**STATE OF HAWAII
DEPARTMENT OF TRANSPORTATION
HIGHWAYS**

**ADDENDUM NO. 1
FOR
TRAFFIC SIGNAL MODERNIZATION, OAHU, PHASE 2
DISTRICT OF HONOLULU
ISLAND OF OAHU
FEDERAL-AID PROJECT NO. STP-0300(213)**

NOVEMBER 7, 2024

TRAFFIC MONITORING AND SIGNAL CONTROL PLAN
Scale: 1" = 20'

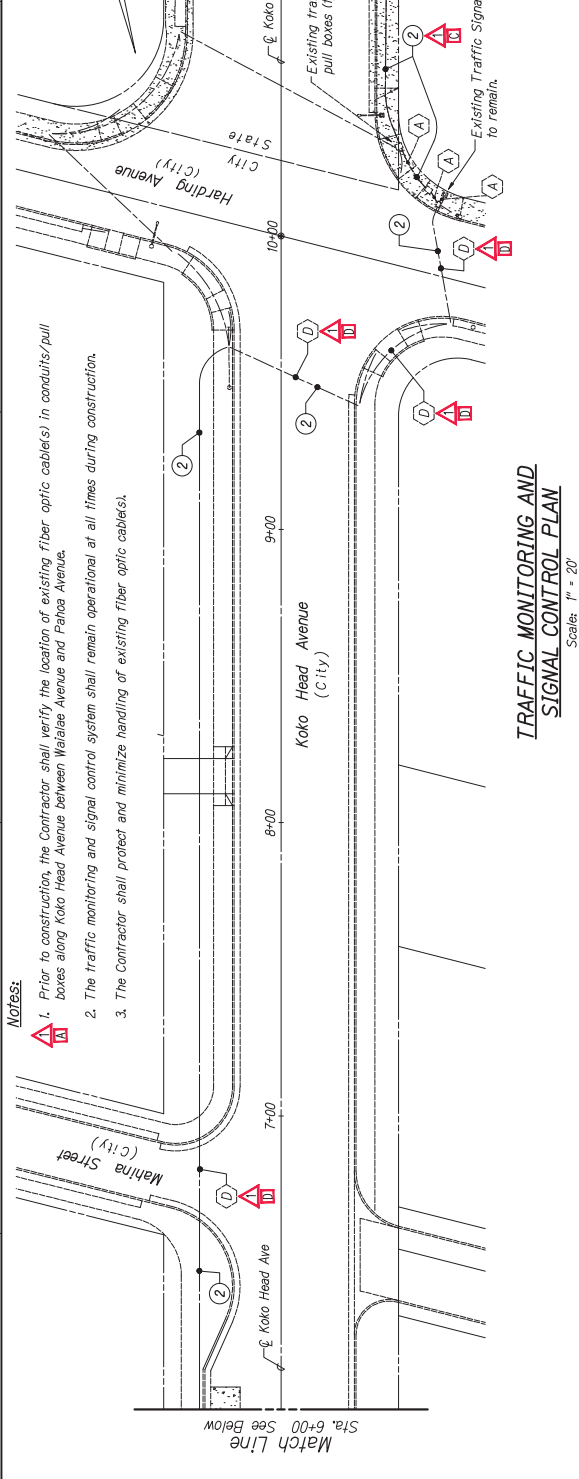
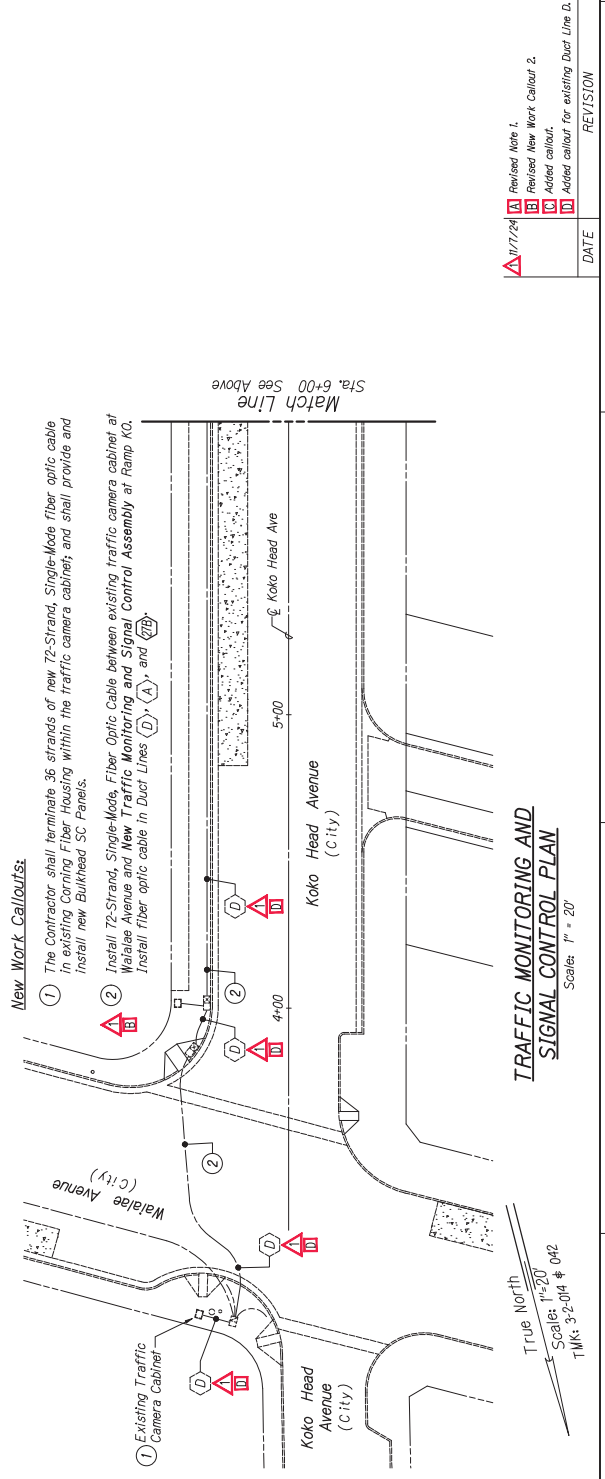
Δ 11/7/24	A	Revised Note 1.
B	B	Revised New Work Callout 2.
C	C	Added callout.
D	D	Added callout for existing Duct Line D.

- New Work Callouts:**
- 1 The Contractor shall terminate 36 strands of new, 72-Strand, Single-Mode Fiber optic cable in existing Corning Fiber Housing within the traffic camera cabinet; and shall provide and install new Bulkhead SC Panels.
 - 2 Install 72-Strand, Single-Mode, Fiber Optic Cable between existing traffic camera cabinet at Waihee Avenue and New Traffic Monitoring and Signal Control Assembly at Ramp (A). Install fiber optic cable in Duct Lines (D), (A), and (B).
